February 23, 2018

EZ-Fill Update

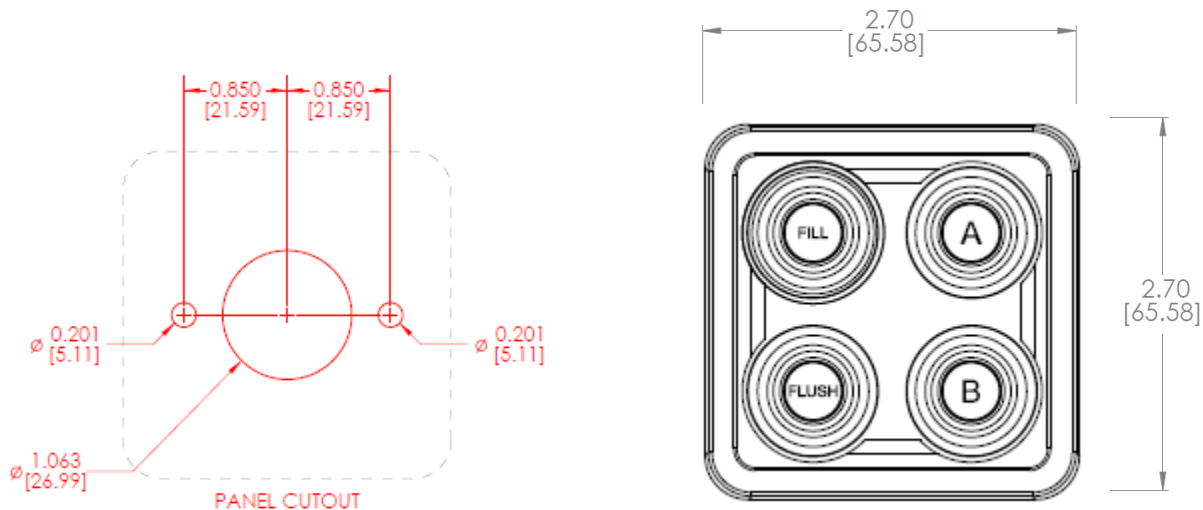
New for 2018, Hale is enhancing the EZ-Fill controller to a color backlit LED version. The size is approximately 0.3” smaller in length and width and will be mounted by two 10-32 studs and operates over CAN J1939. The new controller is more customizable as the colored ring and label are tailored to the application. The backlit rings will turn red or green to correspond to the foam tank selected to act as a visual aid when refilling your foam. In “A” foam operation the buttons are illuminated red, while in “B” they are illuminated green and blue while in “flush” mode. The “B” label pictured below is shipped loose and a blank in its place giving you the flexibility of having “A” only, “B” only, or both labeled. This product will be released in April with any new orders for May delivery.

Any units in the field needing a replacement controller will be retrofitted with this new controller. The retrofit installation kit (546-00074-000) will include an updated harness (513-00141), two nuts for mounting, and H-Bridge (610-00063) when ordering.
